AGENDA

CITY OF OPELIKA
HISTORIC PRESERVATION COMMISSION
October 13, 2022
4:30 p.m.
Meeting Chambers at Opelika Municipal Courtroom
300 MLK Boulevard

HISTORIC PRESERVATION COMMISSION MINUTES

Revised with painted brick

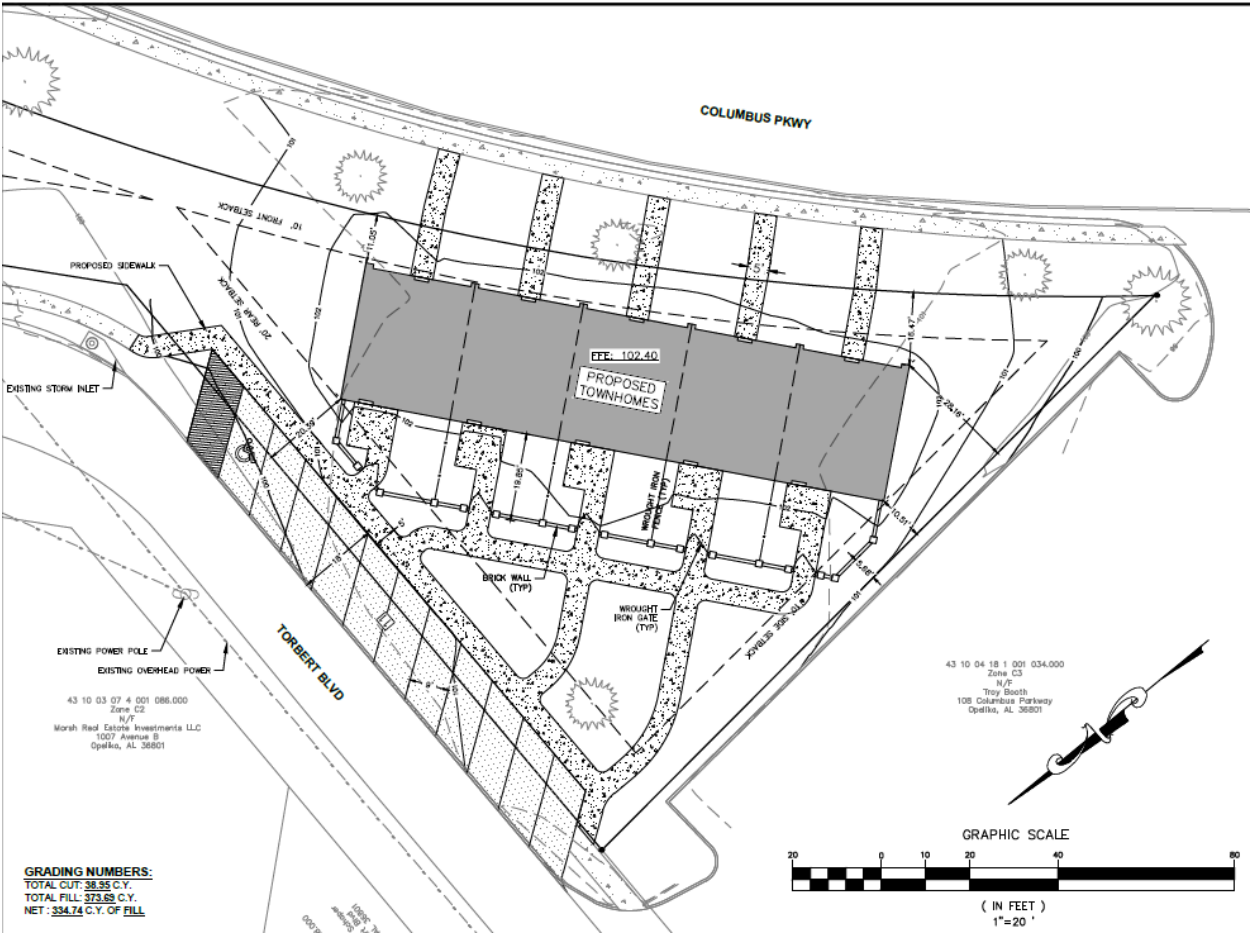
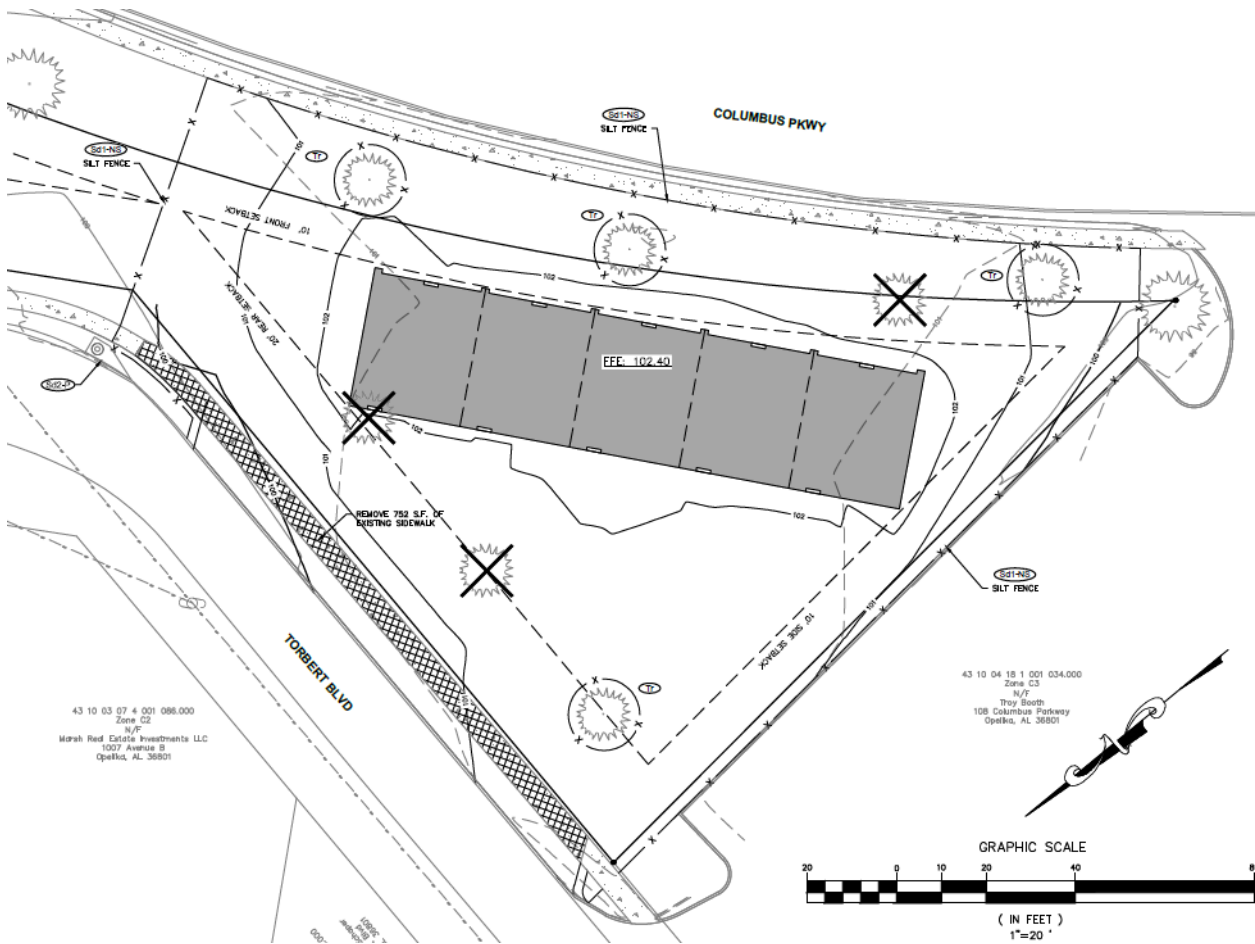
Mark Gatlin began by stating that this part of the Geneva historic district is in a high-profile location. This project is not something that can be taken lightly, it will be very impactful to the historic district. There have been a lot of good and positive things happening in this district in the last few years. Looks like this is slab on grade and the building is about 150 ft wide.

Mark Gatlin said we have ivy on the bottom with the same brick across all five units with very little features breaking up the front other than windows and then a door that's at grade with a piece of metal over the door. There's no porch, no raised slab, it is plain.

Debbie Purves stated that she doesn't see any historic charm or character at all. It says you try to match the surrounding, you take notice of the homes around it, they are all either Victorian or craftsman style. I don't see the character of that neighborhood.

Mark Gatlin stated it looks too governmental.

Debbie Purves stated she would like to see the applicant take what has been said and come back. Change the exterior, the appearance so that it to blends better with the architectural features of the neighborhood in both materials and design.

1. *New construction homes should be compatible with other architectural styles in the district but reflect the era of its own construction. This plan meets the new construction guidelines for height, scale, materials, orientation, and setback.*
2. *Staff recommends windows be wood, wood with aluminum clad, or composite as approved on previous plans.*
3. *Staff recommends wood front door as approved on previous new construction.*
4. *Applicant has received setback approval from the Zoning Board of Adjustment and Planning Department.*
